RFP-39

FCD - 47
FILE NO. 43-C1
APPL. NO. 01-110074
EXHIBIT 31 PHASE 3

CANADA COLLEGE - BURNABY, B.C. & RENOVATIONS
SAN MATEO COUNTY, CALIFORNIA, U.S.A.
FILE NO. 43-C1 APPL. NO. 01-110074
REVISION: 01/12/04
REVISION: 01/12/04

47
ASK-17A

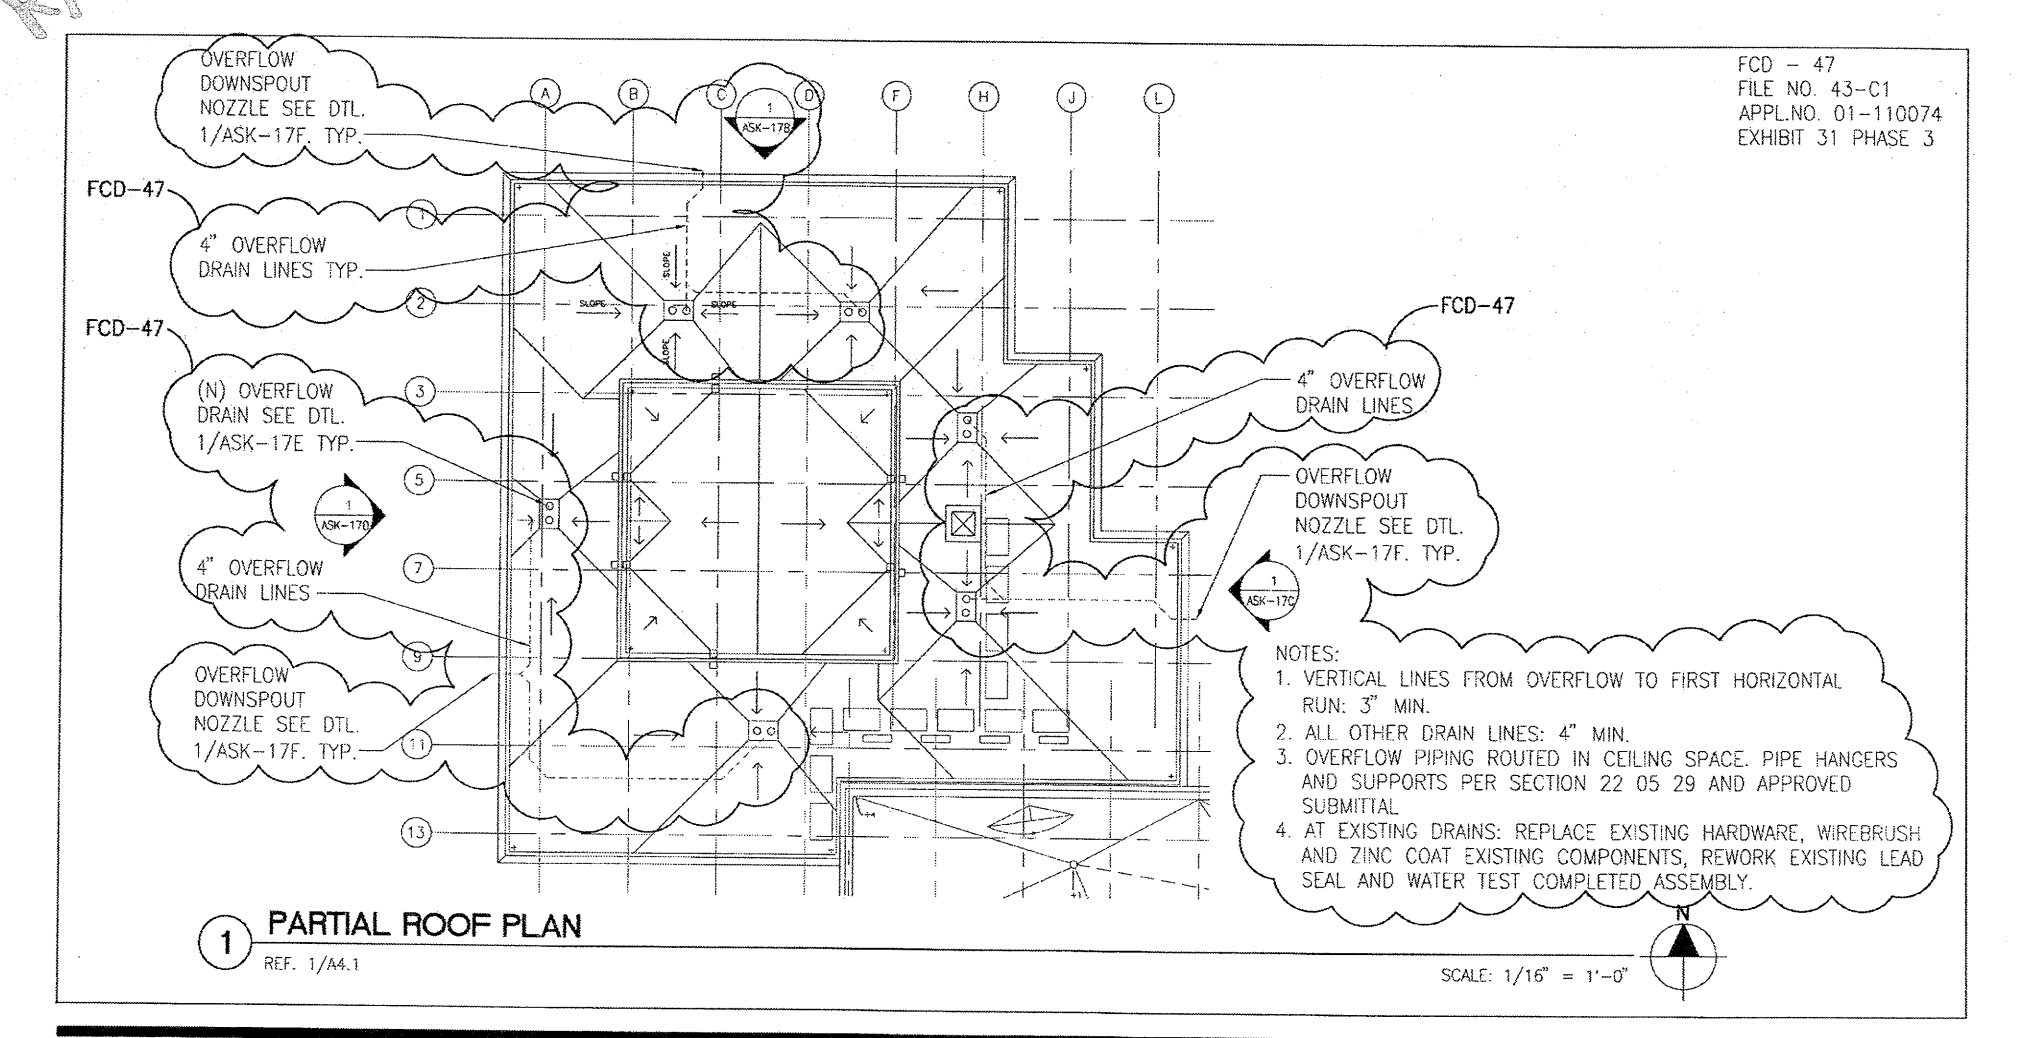
BCA
NEW OVERFLOW DRAIN

- NOTES:
1. VERTICAL LINES FROM OVERFLOW TO FIRST HORIZONTAL RUN, 3" MIN.
 2. ALL OTHER DRAIN LINES: 4" MIN.
 3. OVERFLOW PIPING ROUTED IN CEILING SPACE. PIPE HANGERS AND SUPPORTS PER SECTION 22 05 29 AND APPROVED SUBMITTAL.
 4. AT EXISTING DRAINS: REPLACE EXISTING HARDWARE, WIREBRUSH AND TINE COAT EXISTING COMPONENTS, REWORK EXISTING LEAD SEAL AND WATER TEST COMPLETED ASSEMBLY.
